LANDLORD MECHANICAL COMMENTS:

PROJECT INFORMATION:
24200161
BATH & BODY WORKS
THE GALLERIA II
SPACE NO. 100
5006 WESTMEIER RD.
HOUSTON, TX 77056
FULL REMODEL
EASTON-G
00061216
A/E PROJECT #:
130840

MECHANICAL PLAN

M02.01

MECHANICAL PLAN

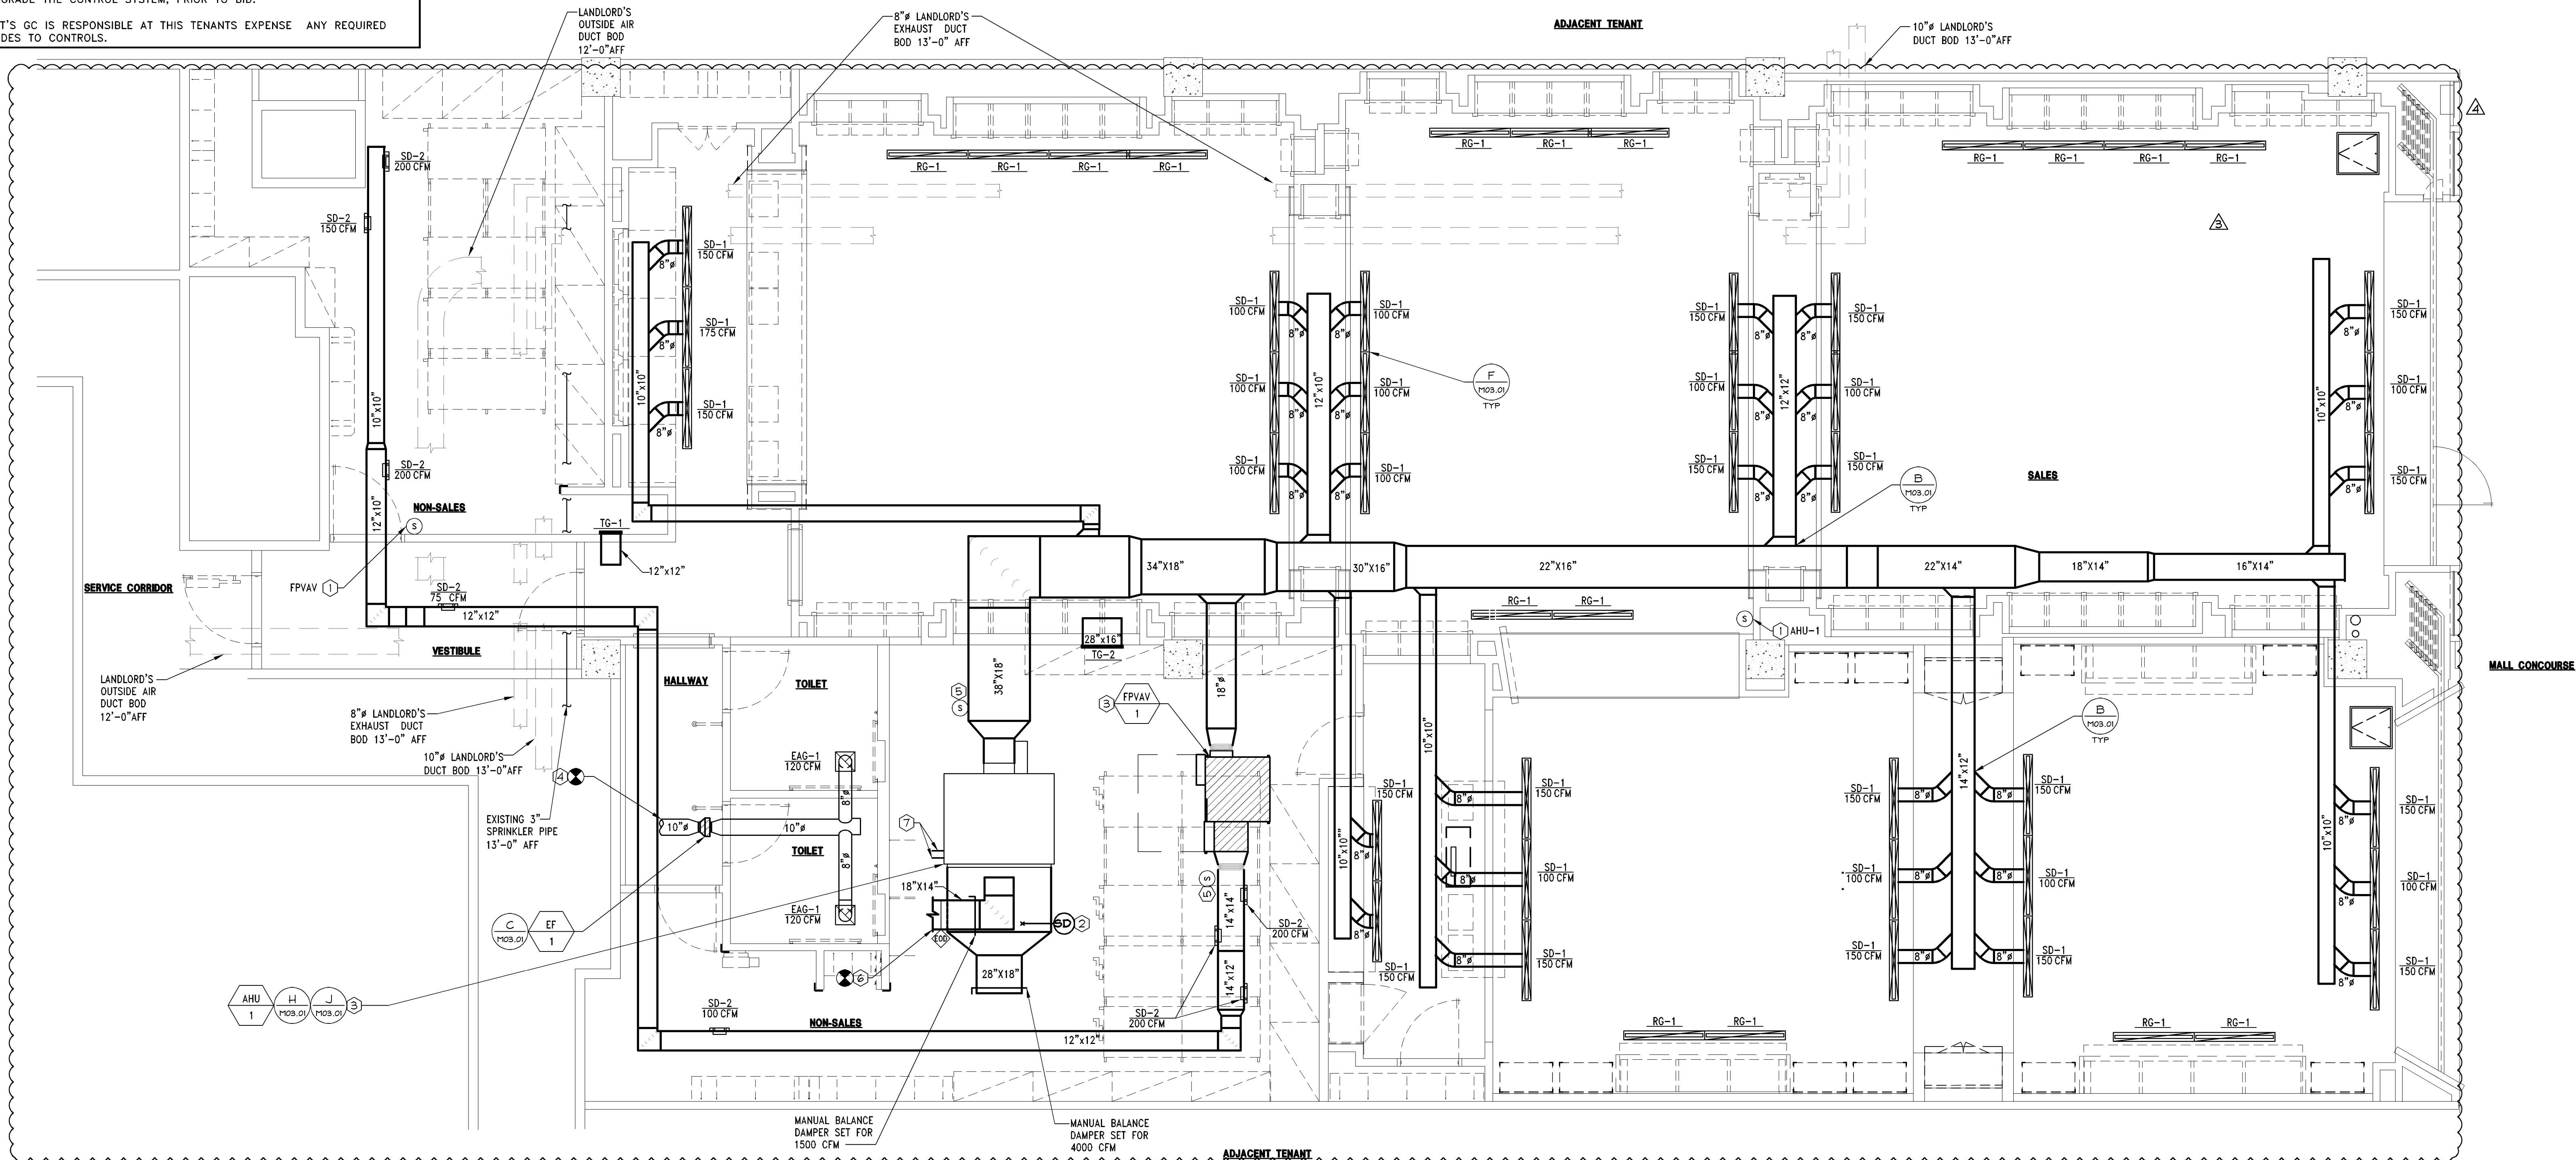
TGC TO CONTACT MALL OPERATIONS TO VERIFY COMPLIANCE OF EXISTING CONTROLS OR TO UPGRADE AS REQUIRED.

ALL DUCTWORK SHALL BE SHEET METAL EXTERNALLY INSULATED. FLEX DUCT MAY ONLY BE USED IN RUNS OF 5'-0" OR LESS AND MAY BE USED FOR VERTICAL CONNECTIONS AND SUPPLY DIFFUSERS ONLY.

EXTERNAL FOIL WRAP INSULATION IS MANDATORY FOR ALL SUPPLY AIR DUCT IN CLOSED CEILING AREAS. TENANT MUST SERVICE AHU. UTILIZE LANDLORD APPROVED HVAC CONTRACTOR AND SUBMIT A REPORT TO MALL MANAGEMENT TO APPROVE REUSE OF EXISTING HVAC EQUIPMENT.

ALL REQUIRED UPGRADES SHALL BE BY THIS TENANT AT THIS TENANT'S EXPENSE.

PLEASE BE ADVISED THAT YOUR HVAC CONTROL SYSTEM MUST BE ELECTRIC AND A CIRCUIT SETTER MUST BE INSTALLED IN THE CHILLED WATER SUPPLY LINE. TENANT SHALL CONTACT THE MALL O.D. REGARDING ALL REQUIREMENTS TO UPGRADE THE CONTROL SYSTEM, PRIOR TO BID.

TENANT'S GC IS RESPONSIBLE AT THIS TENANTS EXPENSE ANY REQUIRED UPGRADES TO CONTROLS.
